WCAP - 15030-NP-A

Westinghouse Methodology
for Evaluating the
Acceptability of
Baffle-Former-Barrel
Bolting Distributions Under
Faulted Load Conditions

**SUBJECT: SAFETY EVALUATION OF TOPICAL REPORT WCAP-15029
"WESTINGHOUSE METHODOLOGY FOR EVALUATING THE
ACCEPTABILITY OF BAFFLE-FORMER-BARREL BOLTING DISTRIBUTIONS
UNDER FAULTED LOAD CONDITIONS" (TAC NO. MA1152)**

SAFETY EVALUATION BY THE OFFICE OF NUCLEAR REACTOR REGULATION
WCAP-15029, "WESTINGHOUSE METHODOLOGY FOR EVALUATING THE
ACCEPTABILITY OF BAFFLE-FORMER-BARREL BOLTING DISTRIBUTIONS UNDER
FAULTED LOAD CONDITIONS"

Figure 2-1 Seismic/LOCA Analysis Approach for Determining Acceptable Baffle - Barrel - Bolting

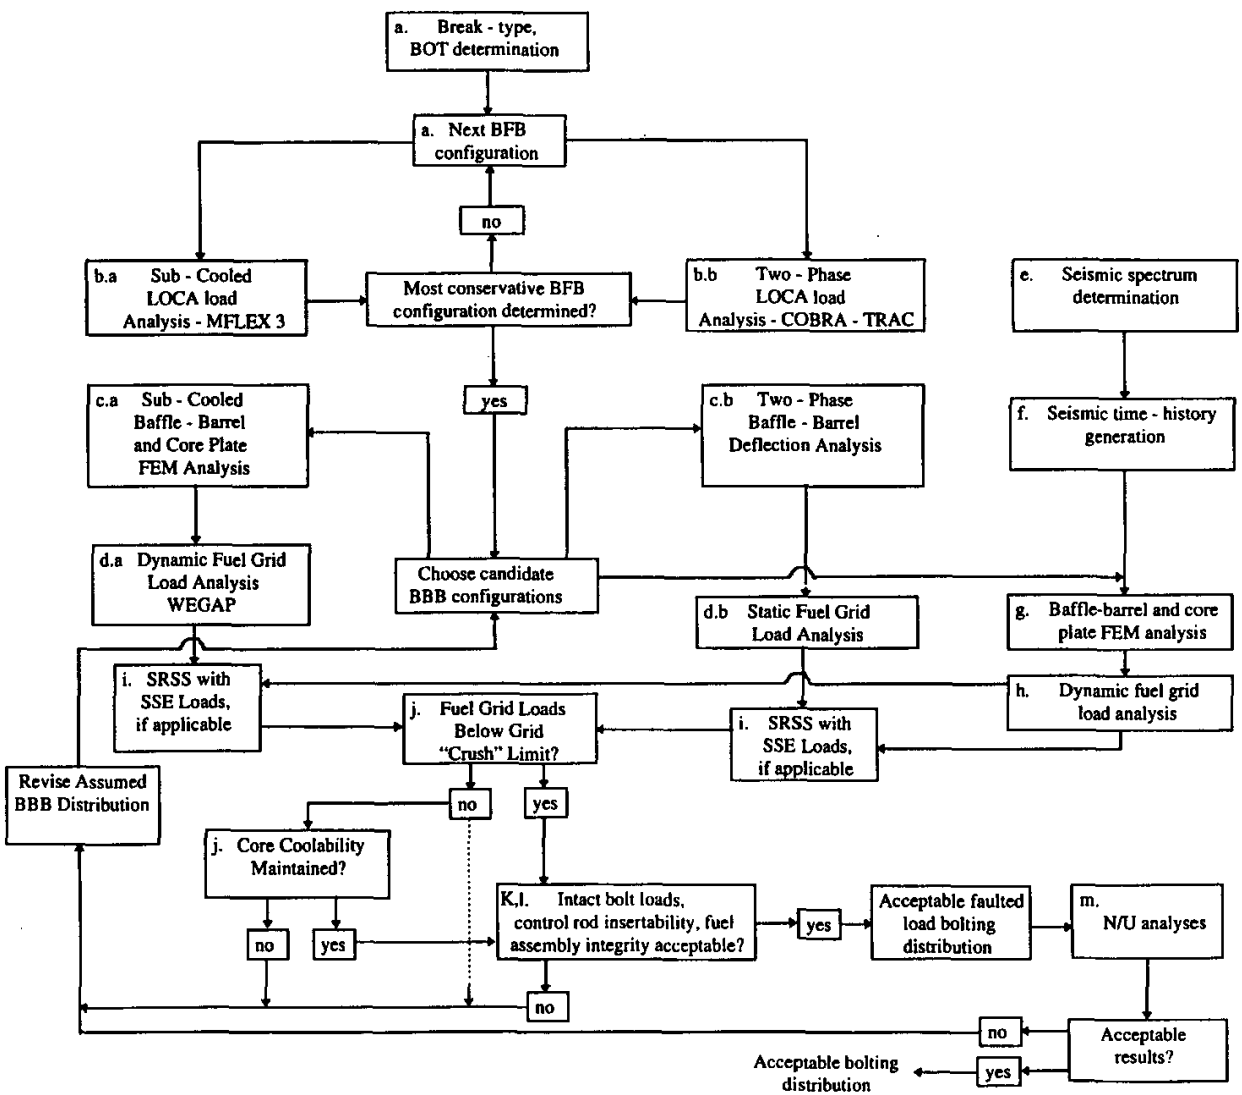
The logic of the methodology depicted in the WCAP-15029 flow chart is an appropriate process for evaluating acceptable bolting loads and distributions. The Multiflex 3.0 program is described as a more sophisticated analysis tool for LOCA hydraulic force calculations than the currently

The use of the WCAP-15029 methodology guidance is acceptable in accordance with the following limitations:

1. The bolt loading should be determined by analysis for a class of plants and a specific break;
2. The noding to be used in the representation of the loading is demonstrated to be adequate by performing nodalization sensitivity studies or by some other acceptable methodology;
3. The methodology should not be used to assess existing bolting without demonstration of adequate conservatism in projected bolting material properties (i.e., yield and ultimate strength) to ensure that sufficient ductility is present in existing irradiated stainless steel bolting materials;
4. The use of the methodology for existing irradiated stainless steel bolting should account for limitations in available ISI methods with regard to the probability of detection characteristics;
